STAFF RECOMMENDATION
201 N 11th Street (0 N 11th Street)
February 17, 2021

Application: New Construction—Infill
District: Lockeland Springs-East End Neighborhood Conservation Zoning Overlay
Council District: 06
Base Zoning: MUL-A
Map and Parcel Number: 08309008800
Applicant: Manley Seale, Architect
Project Lead: Sean Alexander, sean.alexander@nashville.gov

Description of Project: The applicant is proposing to construct a new mixed-use building, with a corner commercial component and a row of six attached townhouses. The building will address N 11th Street and Forrest Avenue, and both components of the building will have three-stories.

1 R5.4-ROOF PLAN
 1/16" = 1'-0"

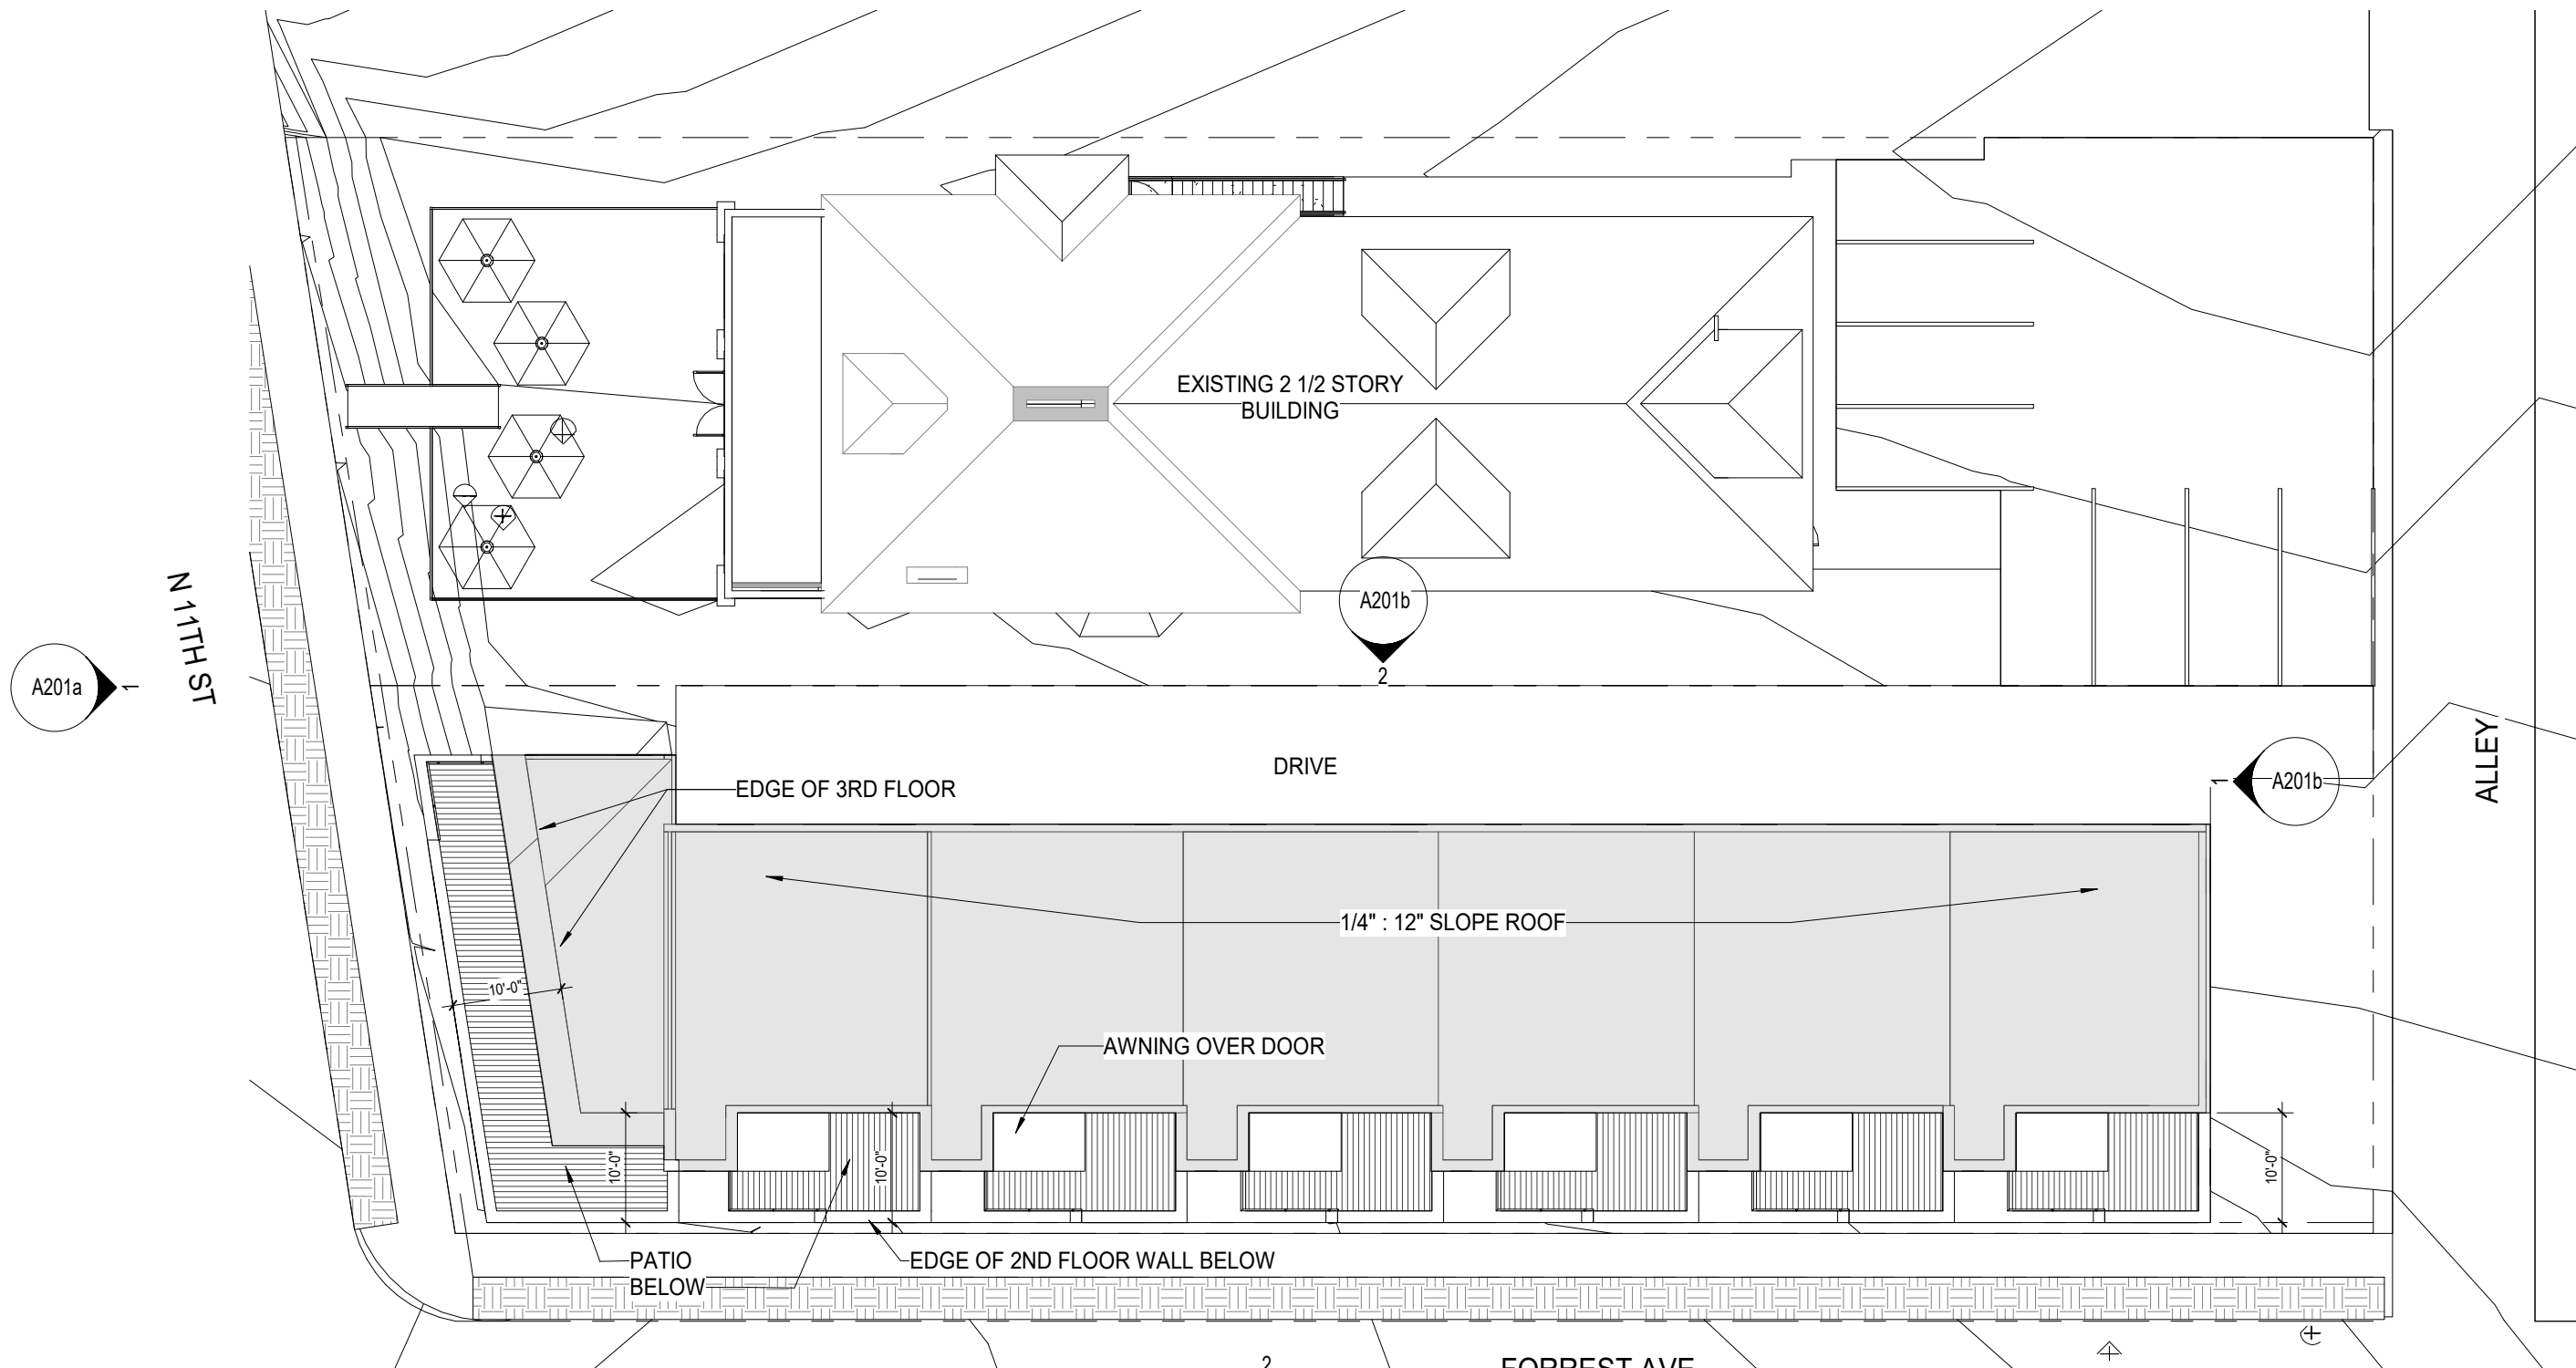
Roof form: The corner commercial component and townhouses have parapet walls acting as a railing for balcony decks at the third-story level, with flat roofs on the third story. Flat roofs are typical of commercial forms. Roof decks and balconies are not typical of the surrounding historic context, on residential or commercial building types.

The proposed roof form does not meet section II.B.5 of the design guidelines.

A201b

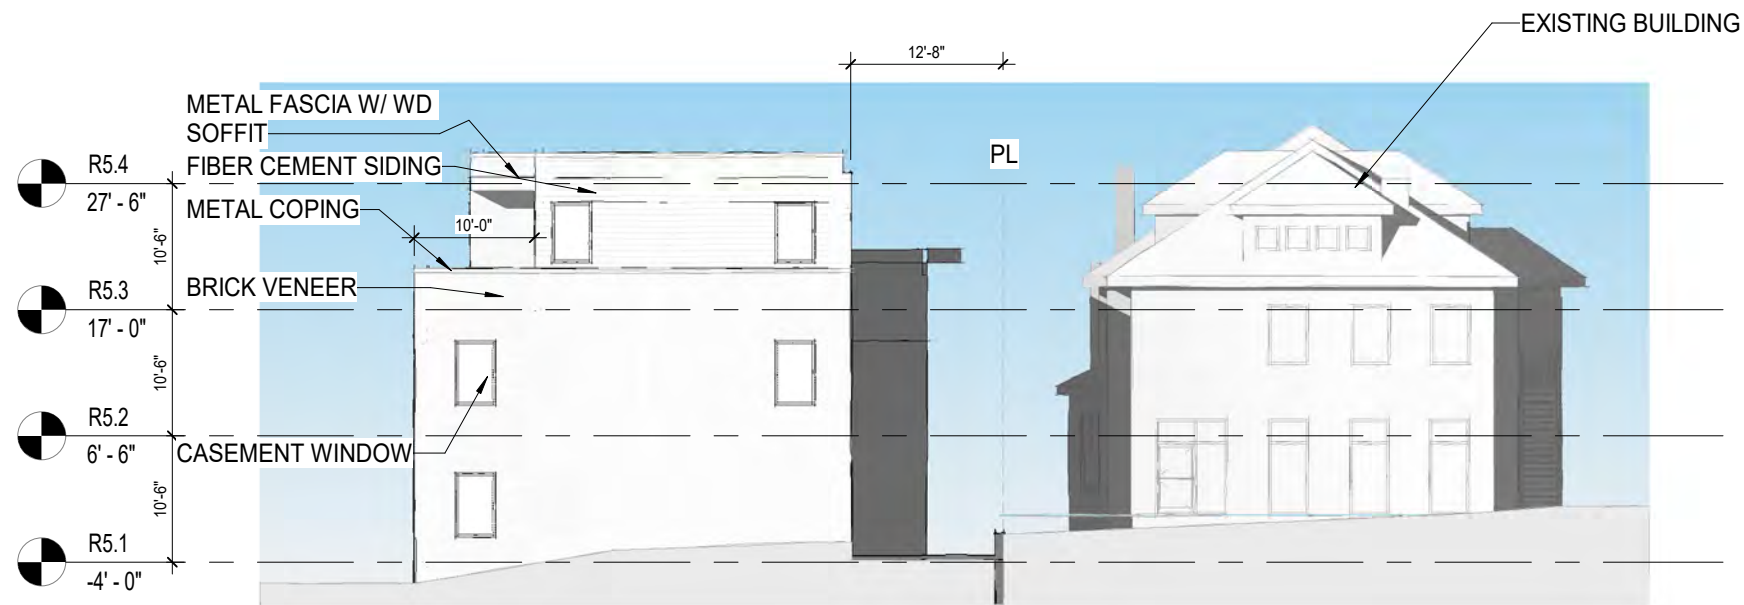
The townhouse component of the proposal attaches to the commercial component and extends one hundred, forty-one feet (141') to the east along Forrest Avenue. The façade will be articulated into six units, with the front wall of each divided up further into three planes. On each unit there will be a two-story wall at the front, eleven feet (11') wide and twenty-six feet (26') tall. The second plane will be stepped back approximately five feet (5') from this wall and will be twelve feet (12') wide and have three-stories with a height of thirty-six feet (36'). The third wall plane will be at the third story only, stepped back ten feet (10') from the first wall plane and five feet (5') from the second. A balcony at the third level will extend out flush with the first plane across a portion of the second. Roof decks and balconies are not typical of the historic context.

Townhouse forms are not common in this area historically; however the proposed development is near the edge of the overlay where the context transitions from residential to institutional and commercial. Because the surrounding area has different forms than are typical of the interior of the neighborhood, staff finds that townhouses may be appropriate at this location although they would not be elsewhere in the neighborhood. However, because the properties directly across Forrest Avenue to the south and across an alley to the east are one and one-half-story residential building types, Staff finds that the third story needs to be fully stepped back at least ten feet (10') from Forrest and from N 11th, and that the easternmost unit needs to taper down to two stories.

Staff finds the scale of the proposed addition does not meet sections II.B.1 and II.B.2 of the design guidelines.
